REMARKS

This is in response to the office action dated June 22, 2004.

FIG. 1A

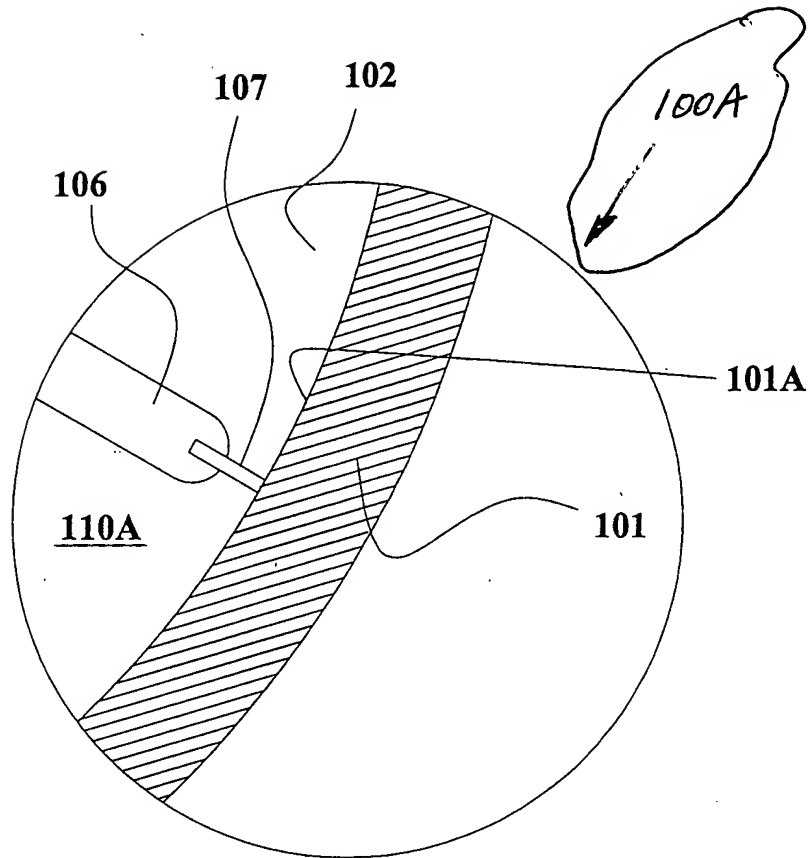
Applicant notes paragraphs 4-6 of the office action and herewith submits corrected drawing Figs. 1A, 1C, 4 and 4A along with marked up changes in red. Applicant wishes to thank the Examiner for the careful review of the application especially in regard to the drawings.
